# UNITED STATES PATENT AND TRADEMARK OFFICE

10/528,664

<b>Office Action Summary</b>	<b>Application No.</b>		<b>Applicant(s)</b>	
	10/528,664		HEAD, PHILIP	
	<b>Examiner</b>		<b>Art Unit</b>	
	Burton S. Mullins		2834

## DETAILED ACTION

Head, Fig.15

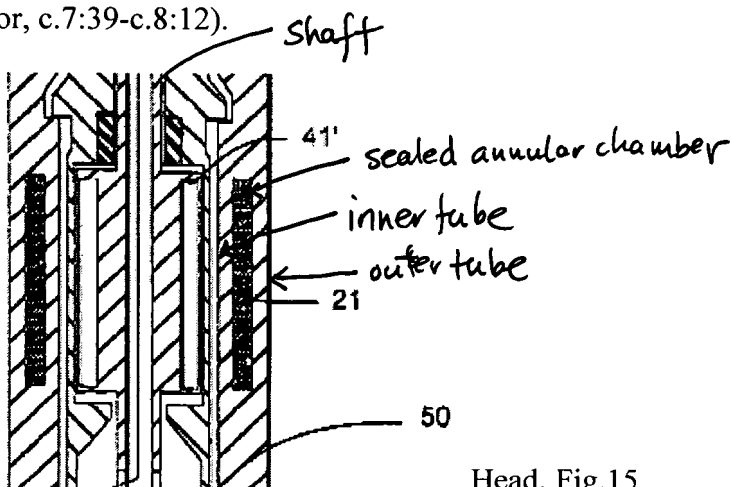
6. Claims 1-8 and 12-14 are rejected under 35 U.S.C. 103(a) as being obvious over Head (US 6,557,642) in view of Mendez (US 5,320,182). Head teaches a brushless dc electric motor for powering downhole tools (Fig.15), the motor comprising: a first stator with conductive windings 21; a shaft (not numbered) centered on and extending along an axis and including a first magnetic element 41' (magnets on rotor circumference); and coaxial inner and outer tubes (not numbered) defining a sealed annular chamber holding the first stators (i.e., stator coil 21), the first magnetic element being aligned with the first stator such that when the winding is energized the stator acts on the magnetic element (i.e., the rotor and stator function as a dc motor, c.7:39-c.8:12).

Head differs only in that the dc permanent magnet motor has only a first stator and rotor, not a second stator and rotor.

Mendez teaches a downhole pump including plural dc motors 60a-60d mounted serially in axially stacked relation, each with stator 62a-62d and permanent magnet rotor (not shown, Fig.1B, c.5:12-27) so as to generate sufficient power to drive the pump to produce a desired flow rate and overcome pressure differentials (c.1:36-43 & 51-65)

It would have been obvious to incorporate plural motors per Mendez into the downhole tool of Head to generate sufficient power to drive the pump to produce a desired flow rate and overcome pressure differentials.

Head Fig.15

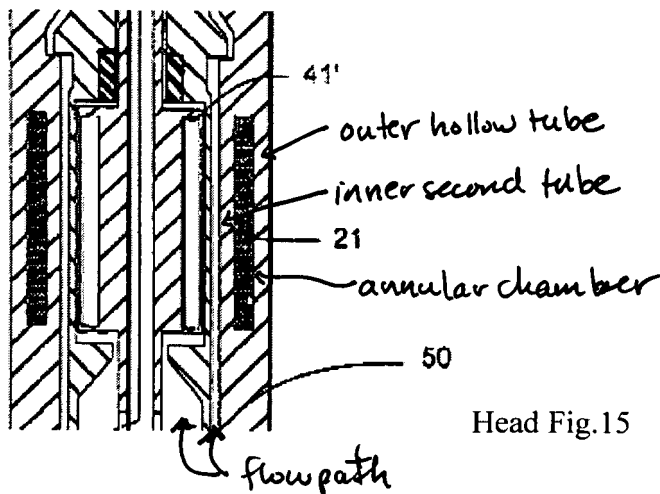
8. Claim 15 is rejected under 35 U.S.C. 103(a) as being unpatentable over Head (US 6,557,642) in view of Eno et al. (US 5,923,111). Head teaches an electric motor suitable for installing in a borehole for powering downhole tools comprising a stator including a first set of coil windings 21; a rotatable shaft including a magnetic element (magnets) 41' (Fig.15); an outer hollow tube (not numbered, see Fig.15 below), and an inner second tube (not numbered) concentrically inside the outer tube together defining an annular chamber (in which stator windings 21 reside), the inner tube defining a flowpath (not numbered, see Fig.15 below), the stator being located in the annular chamber, the rotatable shaft being at least partially tubular (the shaft is inherently tubular).

Head does not teach that the magnetic element (magnet) 41' is "at least partially tubular".

Eno teaches a modular permanent magnet motor for submersible pumps including a rotor comprising a plurality of arcuate (i.e., "partially tubular") magnets 64 (Fig.5) disposed about and attached to rotor core 62 (c.3:65-67; c.4:41-52). The arcuate magnets are configured to facilitate rotation of the rotor modules during energization or de-energization of the coils 80.

It would have been obvious to modify Head and provide partially tubular magnets per Eno to allow for a rotor configuration that facilitates rotation during energization or de-energization of the coils.
